Issue.	Revision	Date
-	Original for DA Issued	2-12-2019

**Statement of Compliance  
Access for People with a Disability**

**Proposed Seniors  
Development**  
3 Central Rd Avalon Beaches

**Report Type:** Statement of Compliance - BCA Access Provisions  
**Development:** 3 Central Rd Avalon Beaches

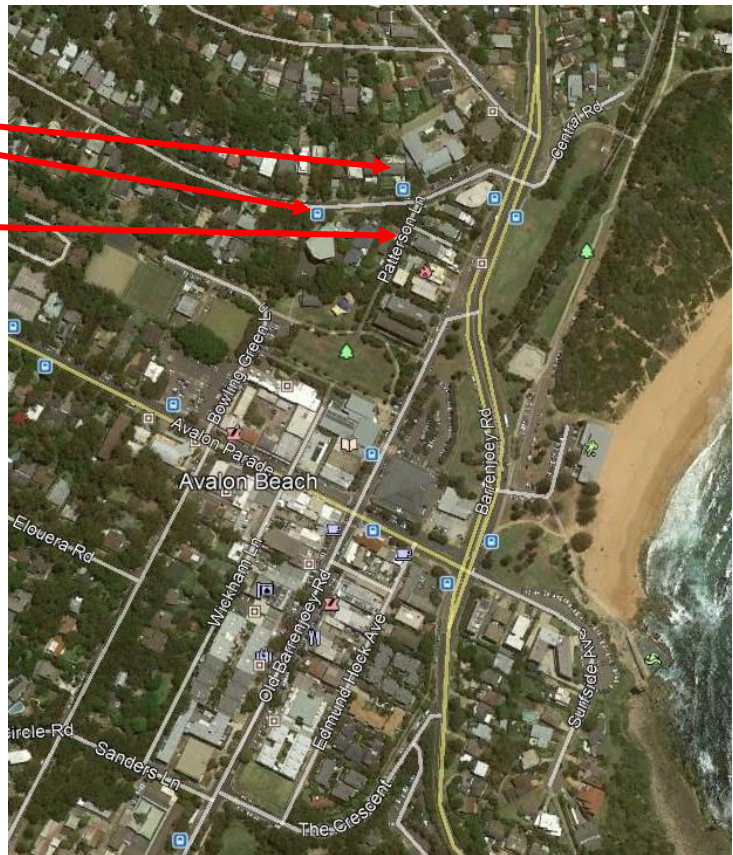
The site is located on in Central Rd to the west and near the intersection with Barrenjoey Rd. The site is served by a number of bus routes which provide access to a greater range of facilities.

Bus stops are located within 100m of the site, travelling in either direction, with the service providing access to Avalon ( Route 192) as indicated on the aerial photo above. There are also bus stops located in Barrenjoey Rd, still within 400m which also provide access to other routes but the path accessing these bus stops does not meet the gradient requirements.

Based on our investigation using a Bosch Inclinometer, the gradients of the path to the bus stops is an average travel gradient no more than 1:14. The gradient is at its maximum directly leading to the southern bus stop at 1:14 for a length of 15m but for most of the travel it is essentially flat.

Directly outside the site there is no formed footpath which will need to be included in the scope of the proposed work. See photo below.
